PROJECT	DATE	BY	REFERENCE
5018551 OHH SID	10/09/2024	SS	5018551-TN-004
TITLE	REVISION		
Response to LLFA Comment	P01

PROJECT:
**ONE HORTON HEATH
SITE WIDE
INFRASTRUCTURE DELIVERY**

TITLE: MAXIMUM INFLOW RATES FROM PARCELS CATCHMENTS 1							
TECH:	CSE:	ICSE:	SCALE:	1:1250	@	A1	
PO			INITIAL ISSUE:	09/09/2024			
STATUS: INFORMATION							
DRAWING No:							
PROJECT:	ORG:	ZONE:	LEVEL:	TYPE:	ROLE:	NUMBER:	REV:
5018551	RDG	XX	ST	DR	C	0555P01

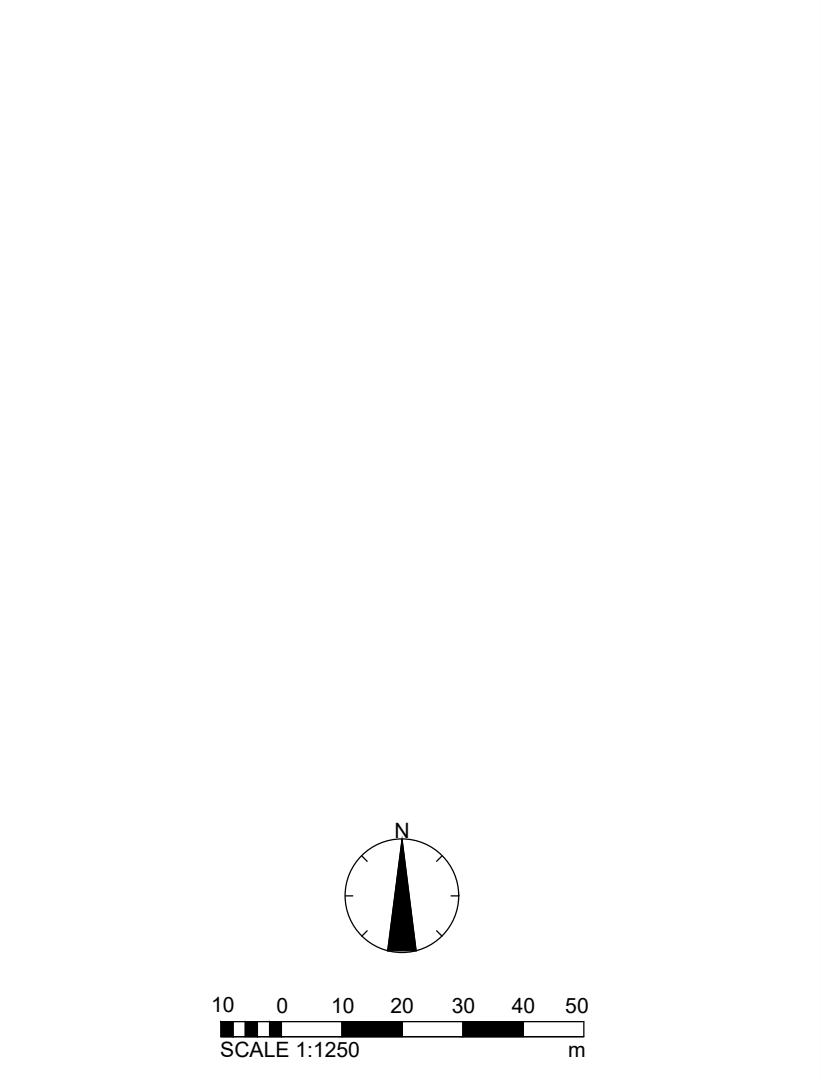
- 2. A clear plan is required showing what flow rate is catered for in relation to the future developments, so it is clear what their discharge rate is. While we have accepted high level calculations based on impermeable area, without the flow rates we will not be able to review future parcels to ensure the downstream network is suitable. This is exacerbated as none of the plans will open due to their size / complexity. The tables in section 3.8 state 'no restriction' in a number of areas. While flows may not need to be restricted, these should list an allowable discharge rate for clarity for future plots.**

- Reference to the plans are drawing No. 0556 and 0555. They have been attached in Appendix A.
